This document outlines National Fuel Gas Supply Corporation's response to the Pennsylvania Department of Environmental Protection Technical Deficiency letter issued for the FM100 Project on December 4, 2020. Each comment has been reproduced and a corresponding answer provided. Where applicable, National Fuel has updated plans and/or drawings and have noted the updates to those documents herein. Revised versions of these documents are being provided in digital format as part of this response. To the extent possible, National Fuel has minimized the number of documents submitted in this response by only providing the applicable items that changed due to the comments below; items not provided with this response were not changed from the previous submission.

**Re: Technical Deficiency #2 Response**

**ESCGP-3 Permit:**

**DEP Application No. ESG830019003-00 APS ID No. 1008279; AUTH ID No. 1299840**

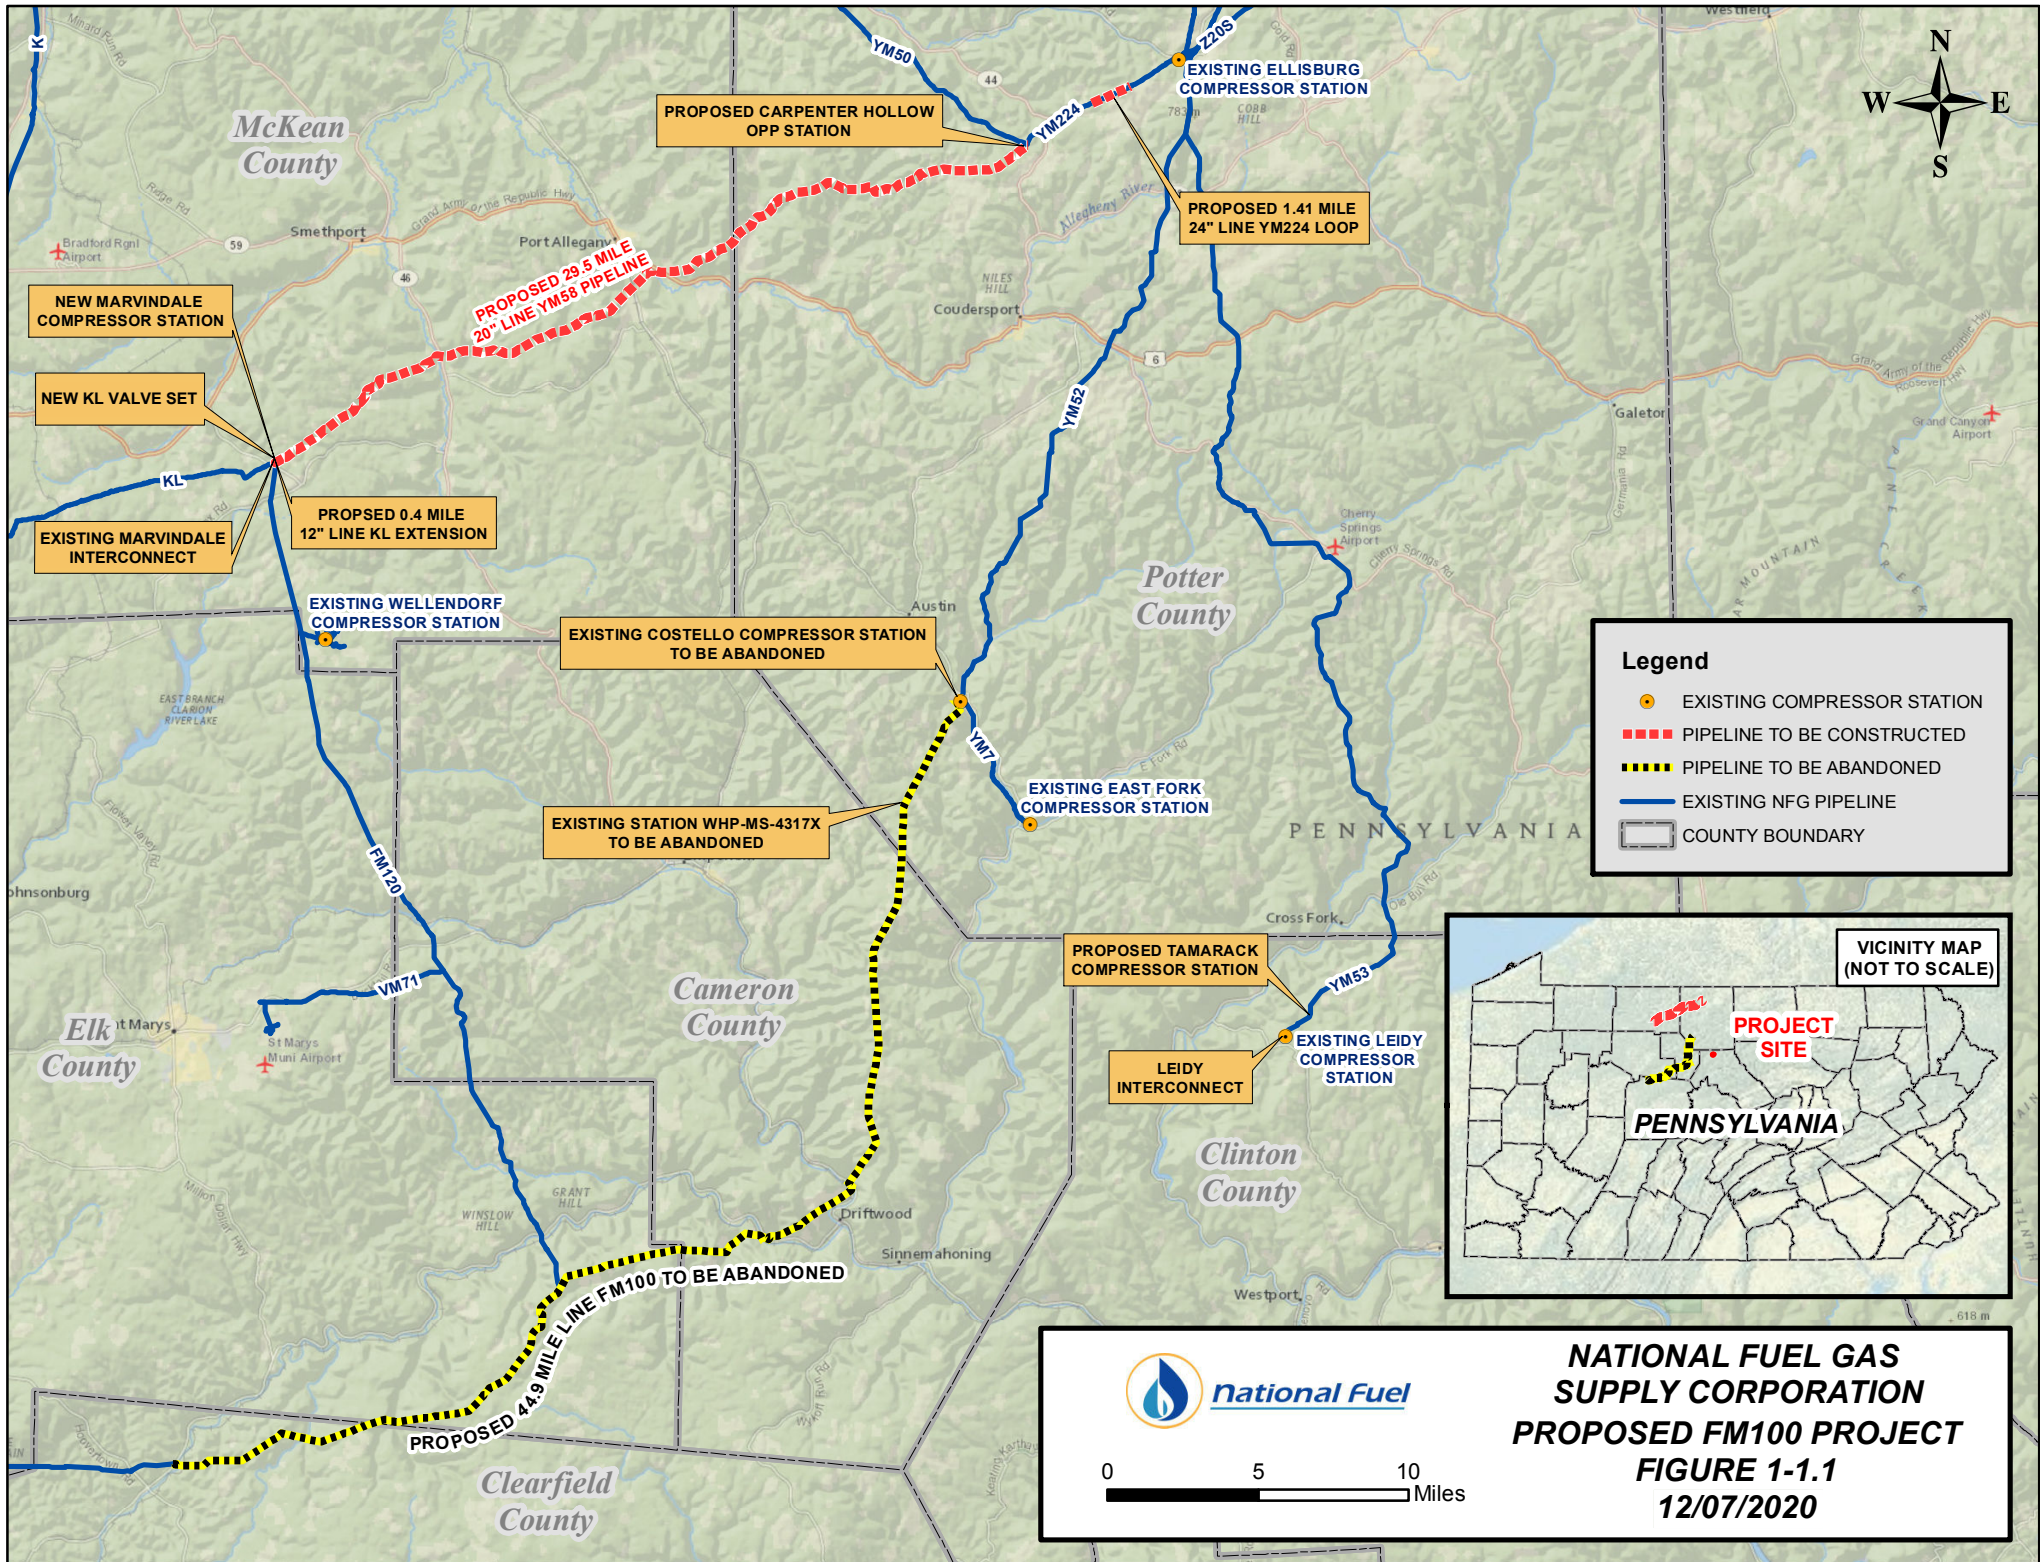
**Q1.** Please make the following corrections to the Summary of Bio-Infiltration BMPs in the NOI 25 PA Code § 102.6(a)(1):

**Q1.a.** The column Elevation of Limiting Zone-Water Table Bedrock etc. has an entry of N/A. This column is applicable. Infiltration tests done as part of the most recent response indicate limiting zones were not encountered, for which an entry of >2ft should be entered. Please update this column to correspond with the submitted information.

**Q1.b.** Please ensure each drainage area is entered properly and corresponds with the submitted PCSM Reports. As an example, the Carpenter Hollow OPP has listed total drainage of 0.356 acres, while in the PCSM Report this number is 1.109 acres.

**Response:** The "Elevation of Limiting Zone-Water Table Bedrock, etc." column of the Summary of Bio-Infiltration BMPs tables have been revised to correctly list a depth of >2 feet for each BMP at each facility.

**Response:** The total drainage for Carpenter Hollow OPP is 1.109 acres and the NOI has been revised accordingly. In addition, drainage areas for each facility were reviewed against the corresponding PCSM reports and updated where applicable.

**FIGURE 1-1.1**

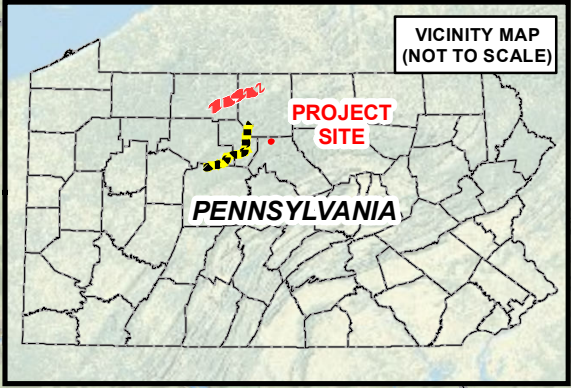
**Q2.** Please revise the Overview Map to reflect the clarification made in the recent response regarding the Marvindale Interconnect. It appears the map label

should reference the KL Valve Set, as the Marvindale Interconnect is existing and does not require any PCSM. 25 PA Code §102.6(a)(1)

**Response:** The Overview Map has been revised to correctly label "NEW KL VALVE SET" and "EXISTING MARVINDALE INTERCONNECT" and is provided as file 01-04-00\_Project\_Overview\_Map\_20201207\_Rev2.
